# Nationally Significant Infrastructure Project West Burton Solar Project

## Local Impact Report - December 2023

- 1.1 This report is the Local Impact Report (LIR) for Lincolnshire County Council (LCC). In preparing this LIR regard has been made to the purpose of LIRs as set out in s60(3) of the Planning Act 2008 (as amended), DCLG's Guidance for the examination of applications for development consent, the Planning Inspectorate's Advice Note One: Local Impact Reports, as well as the Planning Inspectorate's 'Example Documents'.

Figure 1 below is the DEFRA Predictive Best and Most Versatile Land Map.

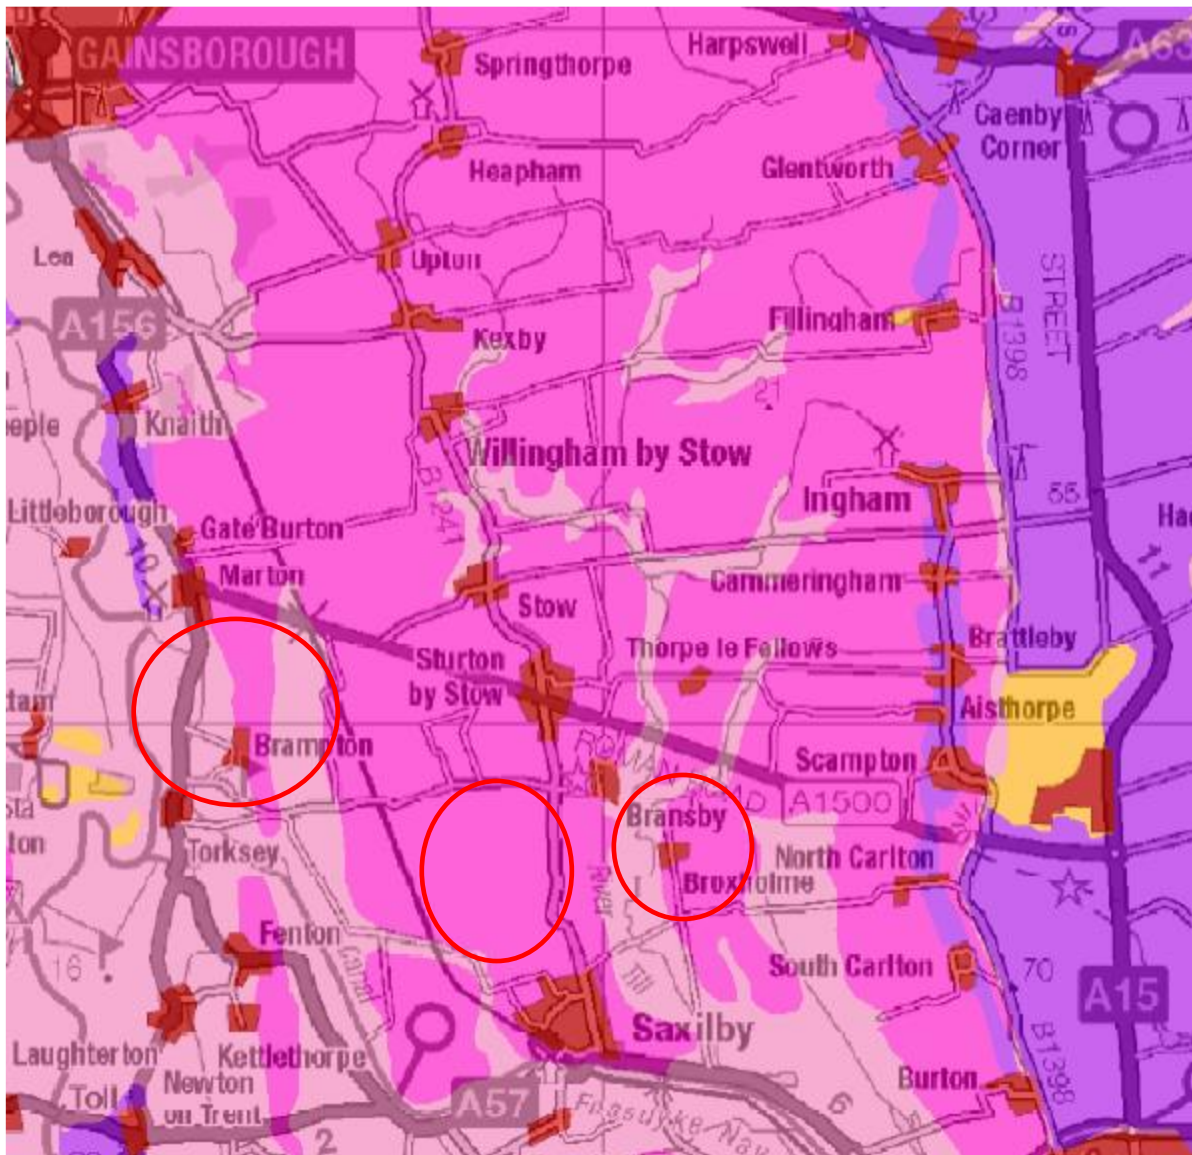
The map shows a Low to Moderate likelihood of best and most versatile land for this area

**Sheet 7:**

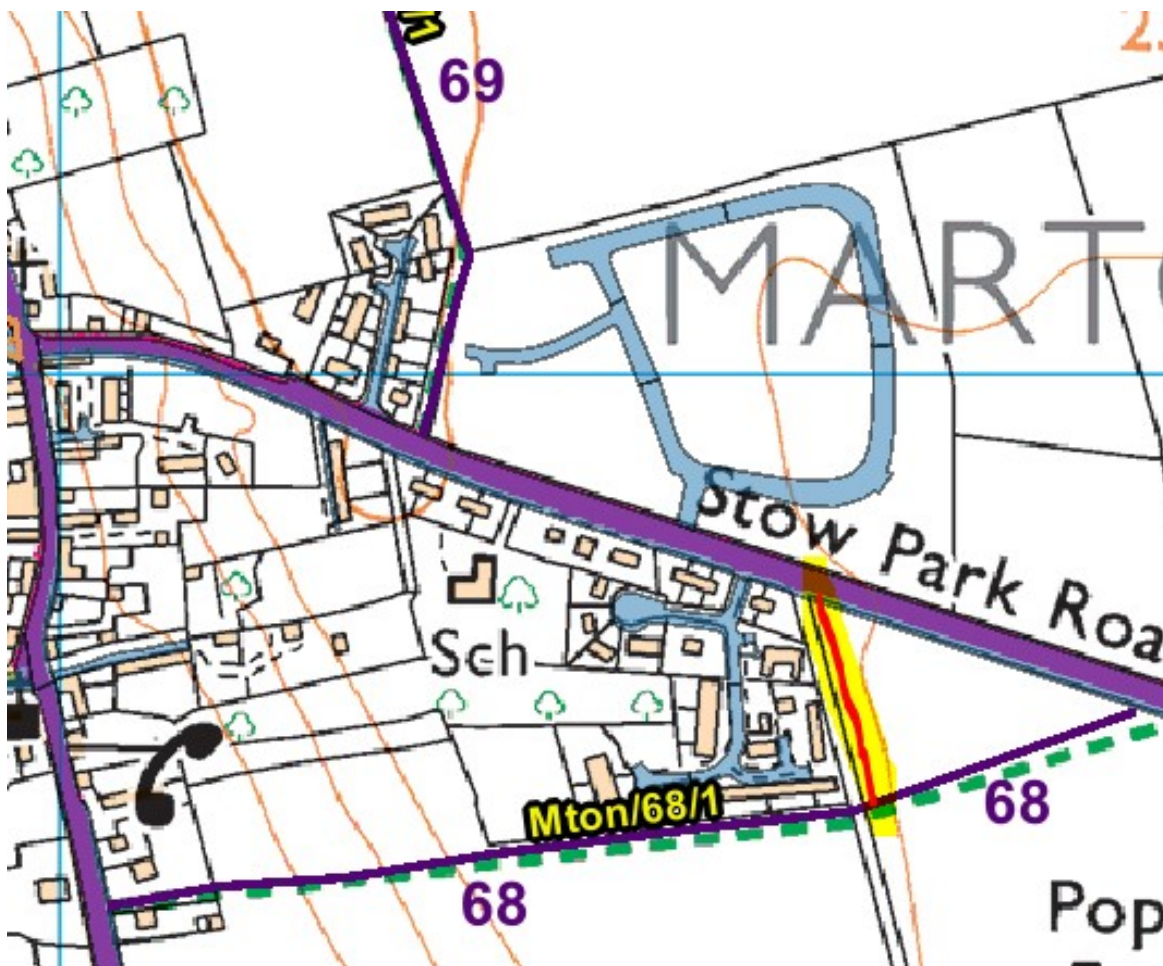
Morton PF68 crosses pink land, and it is considered that there is an opportunity to improve the right of way as part of this development by a permanent diversion to the north, as shown below.

Tillbridge Lane / Stow Park Road is not inviting for onward pedestrian journeys and the termination point of PF68 ends on a busy and fast A road with no ongoing right of way to the north. A permanent diversion of the path alongside the field edge as shown above would reposition the termination point of the path to the 30mph speed restricted part of the road and create a short circular route for residents in Marton and make the path much more attractive and useful. This would also avoid the need for temporary diversion or closure of the path. Some consideration as to the surface of the diverted section of the path would be required however this would be less substantial than anything needed for a temporary diversion.
